PLANNING COMMITTEE A

Committee	PLANNING COMMITTEE A	
Report Title	Land at Sydenham Hill Estate, London, SE26	
Ward	Forest Hill	
Contributors	David Robinson	
Class	PART 1	27 AUGUST 2020

<u>Reg. Nos.</u>	DC/20/115160
<u>Application dated</u>	3 January 2020
<u>Applicant</u>	Peter Brett Associates on behalf of City of London Corporation
<u>Proposal</u>	Demolition of existing buildings at Mais House and Otto Close garages, SE26, and redevelopment to provide a part four, six and seven storey building and a part two and three storey terrace building providing a total of 110 residential units (use class C3), community room and estate office; together with alterations to the existing ball court; associated works to vehicular and pedestrian access from Sydenham Hill, Lammas Green and Kirkdale; provision of car and cycle parking, refuse storage and landscaping including amenity space and play area.
<u>Background Papers</u>	(1) Case File DE/345/44/TP (2) National Planning Policy Framework (3) The London Plan (4) Local Development Framework Documents
<u>Designation</u>	Area of Special Character Sydenham Hill Conservation Area Lammas Green Article 4(2) Direction PTAL 3 Strategic Site Allocatio

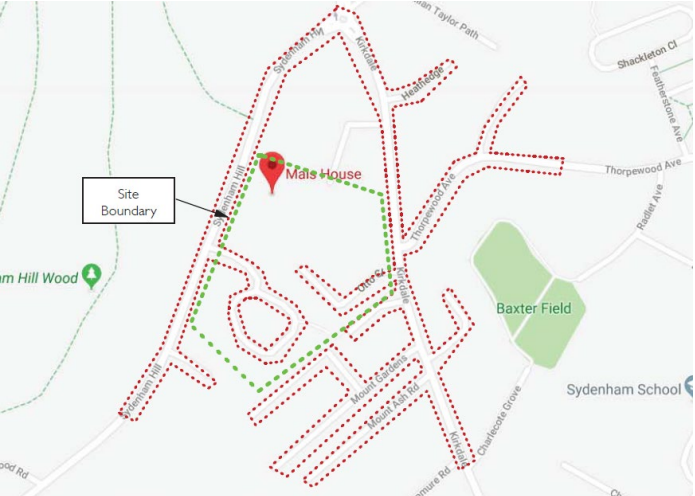
62.	The response regarding Carstlebar daylight impact is unacceptable. Doing guess work based on a person's opinion from an "external inspection" is totally unacceptable. Clearly the applicant provided a misleading daylight report as this "opinion" about an "external inspection" was omitted and makes their report substandard. This is important as many residents (including my Mum in this home) are too frail to access other rooms and so is more significant. My question was What will be done to correct this Daylight report and by when and to use accurate room layouts? Please reply in writing to Francis Bernstein	When plans cannot be obtained for a neighbouring building, room layouts based upon external inspection and professional judgement is the conventional approach. The internal room layouts are only applicable to one of the daylight tests. The VSC and sunlight levels are taken at the window plane and are therefore not reliant on the internal room layouts. Now that we have been furnished with the internal layout plans our analysis will be updated accordingly.

Sydenham Hill - path network and gradients diagram

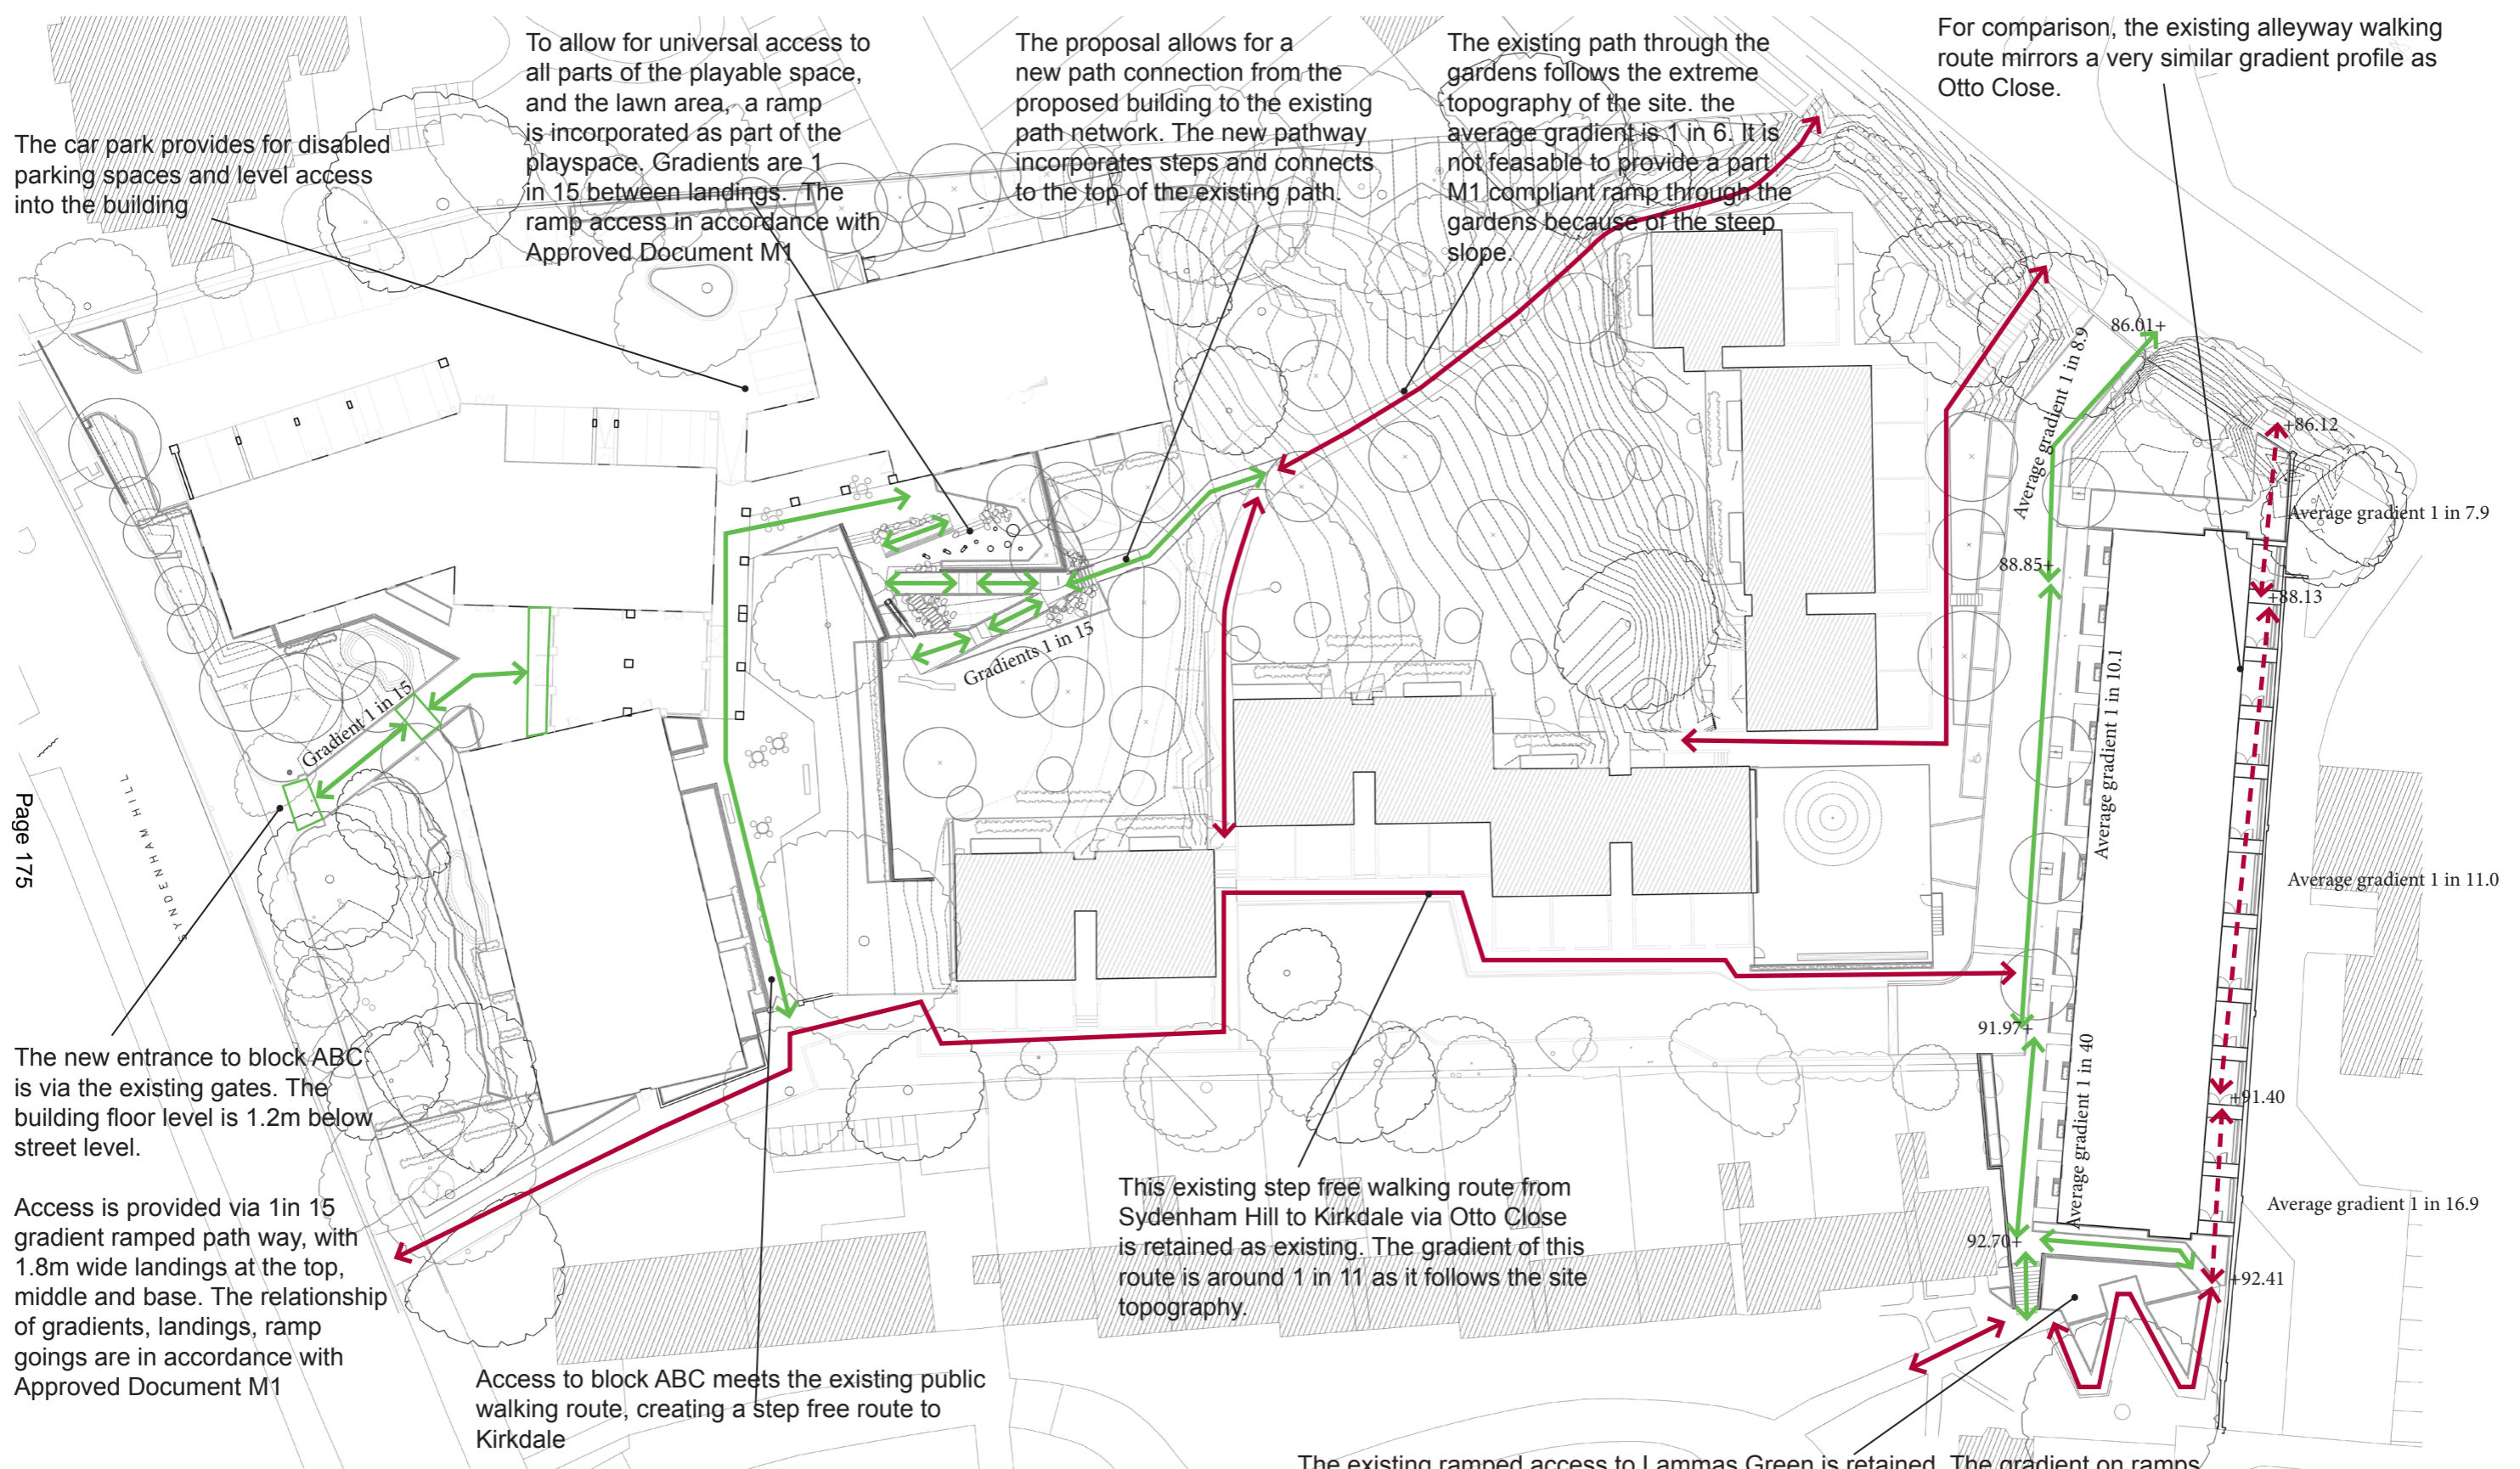
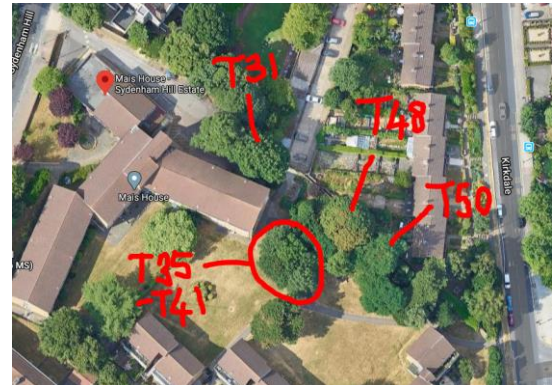
242	<p>What is the gradient <u>at the steepest section</u> for the <u>step free</u> access from Kirkdale road to access the properties at the top of the development (nearest to Sydenham Hill), and, what length of footway slopes are there between <u>level resting platforms</u> required by manual wheelchair users to use?</p>	<p>Refer to response to qu.s 145-151 and attached plan. Accessibility requirements to the proposed building and across the estate have been fully considered.</p>
-----	--	---
